SCHEMATIC CONDUIT DIAGRAM  
 OVER LEWES & REHOBOTH CANAL  
 SAVANNAH ROAD BRIDGE

SAVANNAH ROAD BRIDGE  
 LEWIS I. DEBEL  
 SCALE: AS LISTED  
 DATE: 1/21/83  
 PASCALE LEAF LIGHTING & POWER  
 TUDOR Z ELEC  
 DRAWING NUMBER  
 OFFICE COPY

HARDESTY & HANOVER  
 CONSULTING ENGINEERS  
 W. B. Burgess  
 MAY 2, 1983

DETAIL AA  
SCALE 3" = 1' FOOT

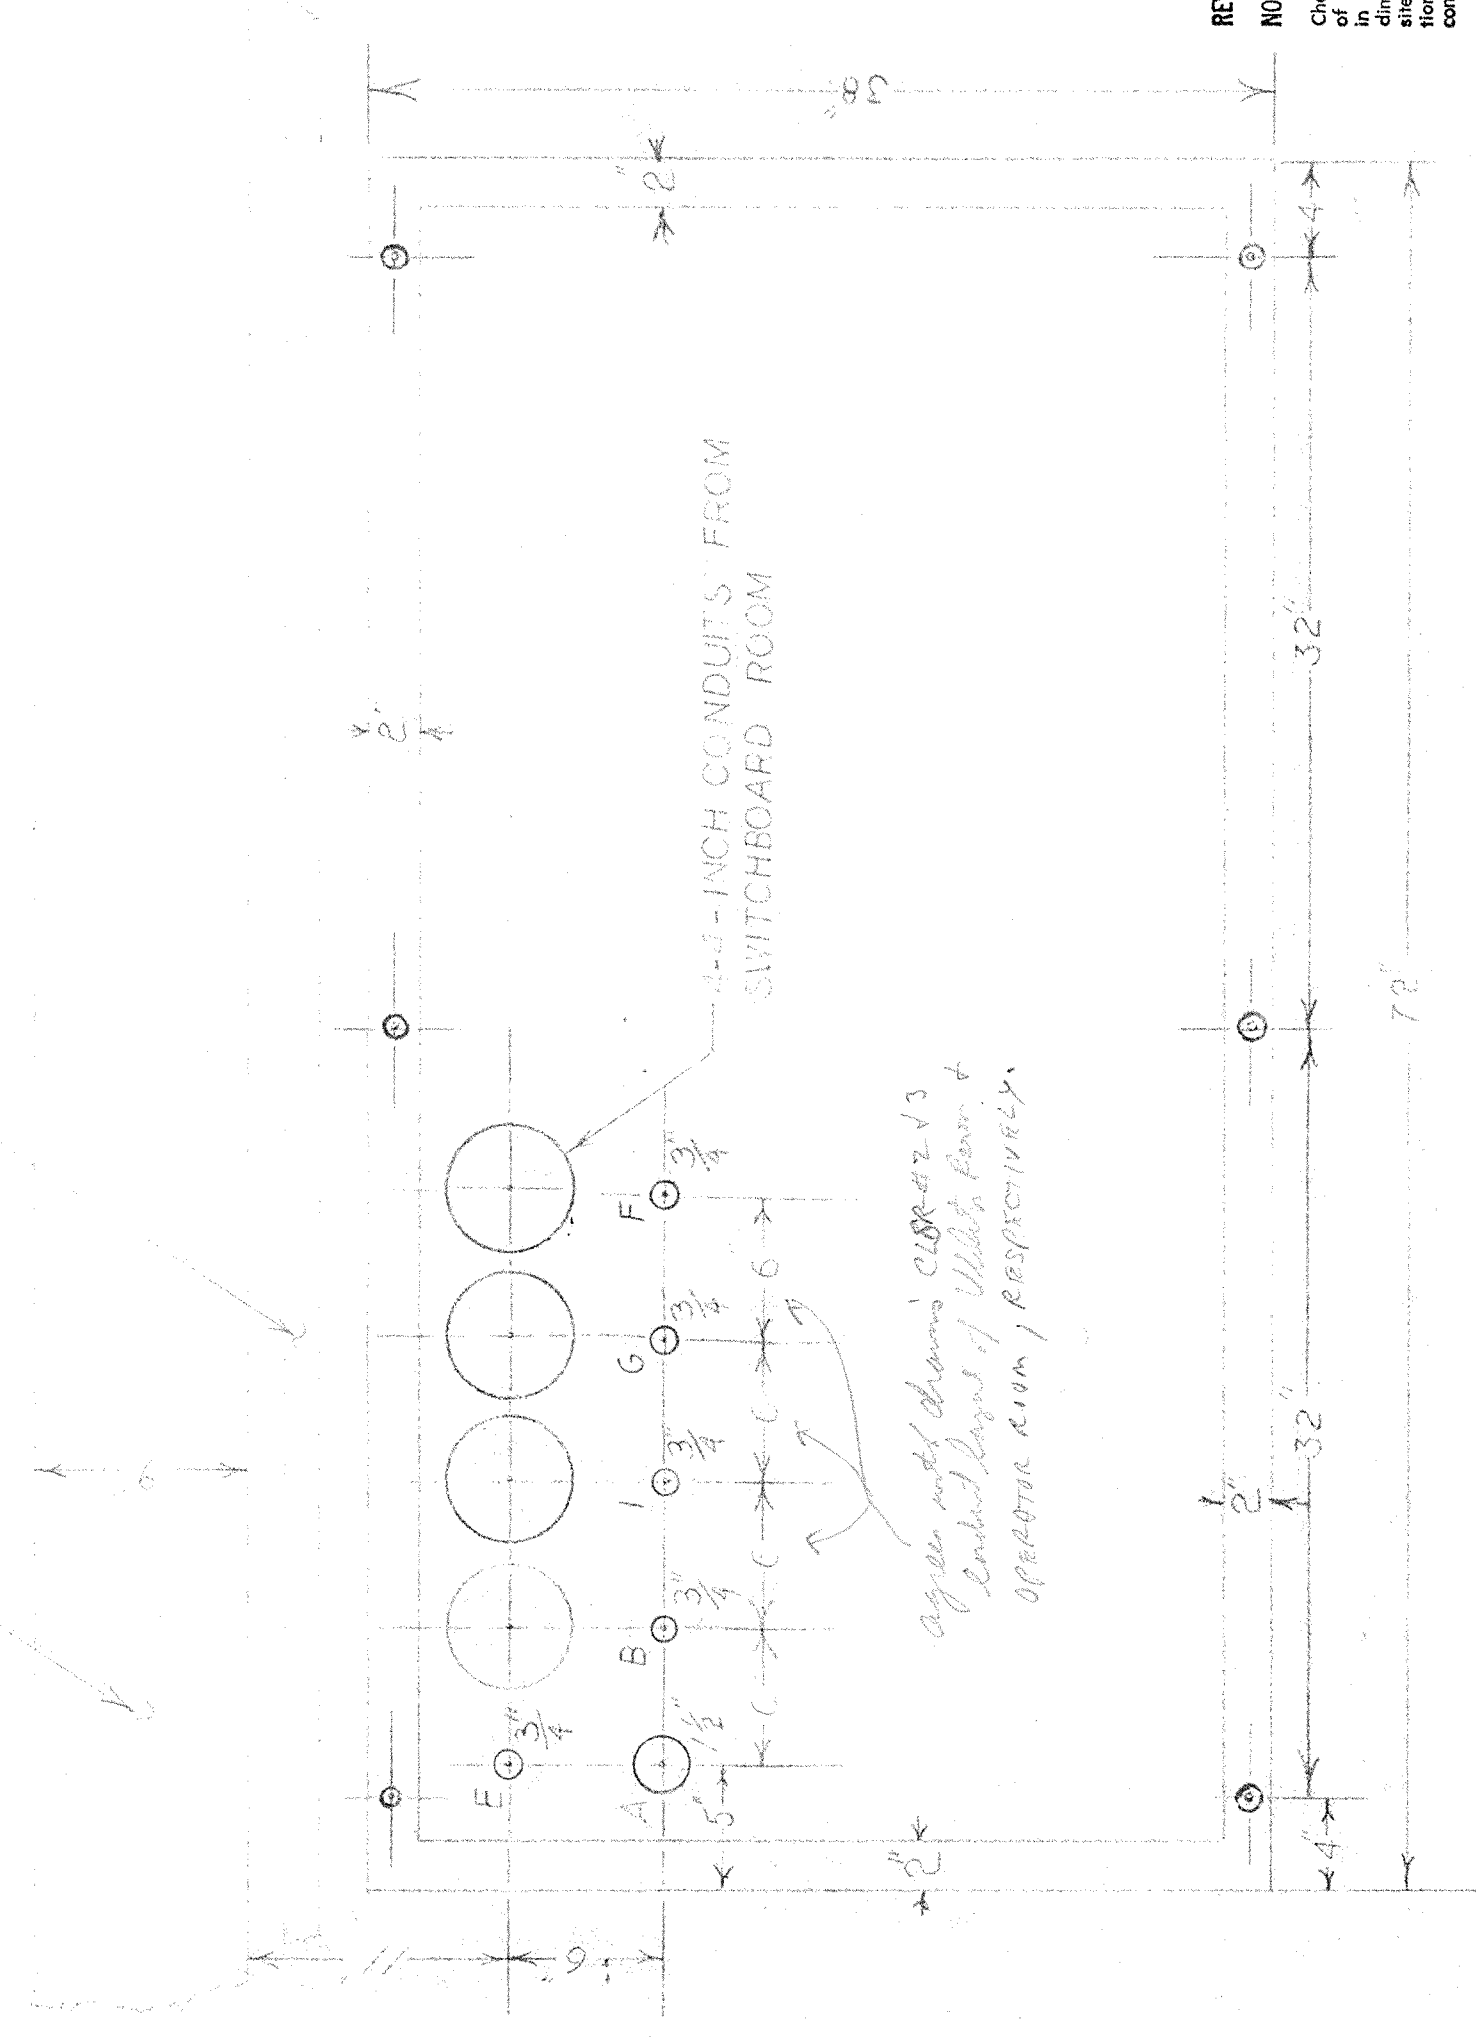
SUPERSEDED  
 Provide a better numbering system for your drawings
